Access Compliance Report

Public Rights-of-Way

(Curb Ramps)

Intersection ID: 47846	Main Street: ALVARADO_WY	Cross Street: STONE_PORCH_RD	Location: SE
ADA ID: 1DA374AAB299	Ramp Type: BlendTrans1	Initial Pass/Fail: Fail	Overall Compliance: No
Severity Score: 8.75			
Codes/Mitigation Info/Possible Solution		Field Measurements/Component Compliance

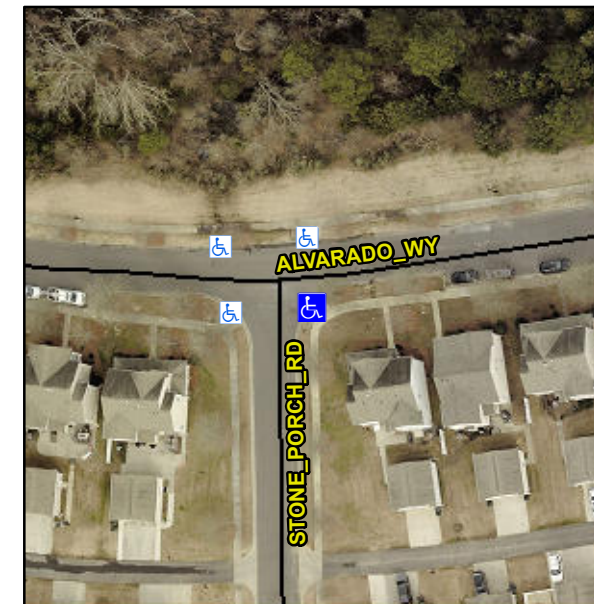
Remove & Replace Curb Ramp With Two New Directional Ramps or Equivalent.

Not Found, R304.5.1

Compliance	Description	Data	Compliance	Description	Data
N/A	Ramp Length (in)	78.0	Yes	BlendTrans Slope (%)	4.4
No	Ramp Width (in)	46.0	Yes	BlendTrans XSlope (%)	0.9
N/A	Flare Type LT	N/A	N/A	Flare Type RT	N/A
N/A	Flare Slope LT (%)	N/A	N/A	Flare Slope RT (%)	N/A
N/A	Flare Traversable LT?	N/A	N/A	Flare Traversable RT?	N/A
N/A	Landing Length (in)	N/A	N/A	DWS Provided?	N/A
N/A	Landing Width (in)	N/A	N/A	DWS Contrast?	N/A
N/A	Landing Slope (%)	N/A	N/A	DWS Length (in)	N/A
N/A	Landing X Slope (%)	N/A	N/A	DWS Full Width?	N/A
N/A	Landing Curb? (Y/N)	N/A	N/A	DWS Offset (in)	N/A
N/A	Shared Landing?	N/A			
N/A	Gutter Ponding?	N/A	N/A	Gutter Slope (%)	N/A
N/A	Gutter Lip Ht (in)	N/A	N/A	Gutter X Slope (%)	N/A
N/A	Painted X Walk1?	No	N/A	Painted X Walk2?	No
	X Walk 1 Direction	To N		X Walk 2 Direction	To W
	X Walk 1 Width (in)	N/A		X Walk 2 Width (in)	N/A
	X Walk 1 Slope (%)	1.9		X Walk 2 Slope (%)	0.2
	X Walk 1 X Slope (%)	1.6		X Walk 2 X Slope (%)	1.6

N/A	Ramp inside XWalk1?	N/A	N/A	Ramp inside XWalk2?	N/A
	Road Slope (%)	1.0		Clear Space?	N/A
	Road X Slope (%)	0.9	N/A	Clear Space to XWalk (in)	N/A
N/A	Any Obstructions?	N/A	N/A	Storm Grate/Utility Hazard?	N/A
	Obstruction Type			Storm Grate/Utility Type	
		N/A			N/A
			Yes	Surface Condition? (G/P)	Good
			No	Curb Slope (%)	6.7
